Office Action Summary	Application No. 10/553,568	Applicant(s) PHILIPPE, NOELLE	
	Examiner Thai-Ba Trieu	Art Unit 3748

DETAILED ACTION

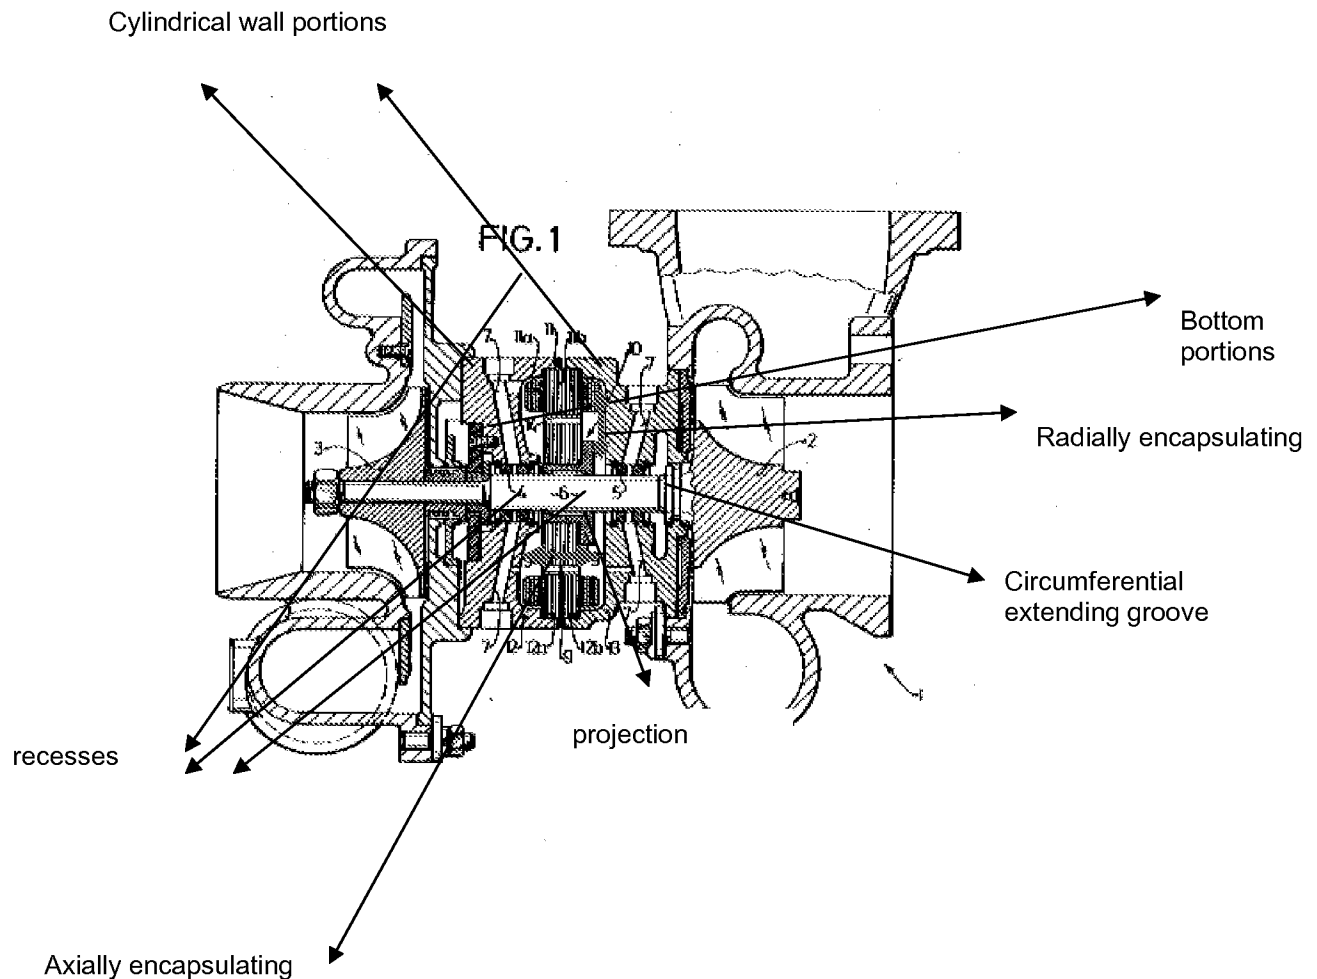
a turbine housing (Not Numbered) for accommodating a turbine wheel (2) driven
by exhaust gas;

a center housing (12, 13) for accommodating a shaft (6) and the electric
motor (10), the shaft serving as a rotor (9) of the electric motor (10) and extending from
the turbine wheel (2) through a journal bearing (4,5) and the electric motor (10) to a
compressor wheel (3);

a compressor housing (Not Numbered) for accommodating the compressor
wheel (3);

the compressor wheel (3) is driven by the turbine wheel (2) via the
shaft (6) and can additionally be driven by the electric motor (10), and

the electric motor (10) is accommodated in the center housing (12, 13)
such that the electric motor (10) is firmly fixed by connecting the center housing
(12, 13) to the compressor housing (Not Numbered) (See Figure 1);

wherein one of the cartridge housing portions (12, 13) serves as a seal plate on the journal bearing (4,5) side and the other cartridge housing portion (12, 13) serves as a backplate on the compressor wheel (3) side;

The examiner respectfully disagrees, since Frister does disclose a stator is radially and axially encapsulated there between an assembled cartridge formed by two portions, which is shown in attached Figure 1.
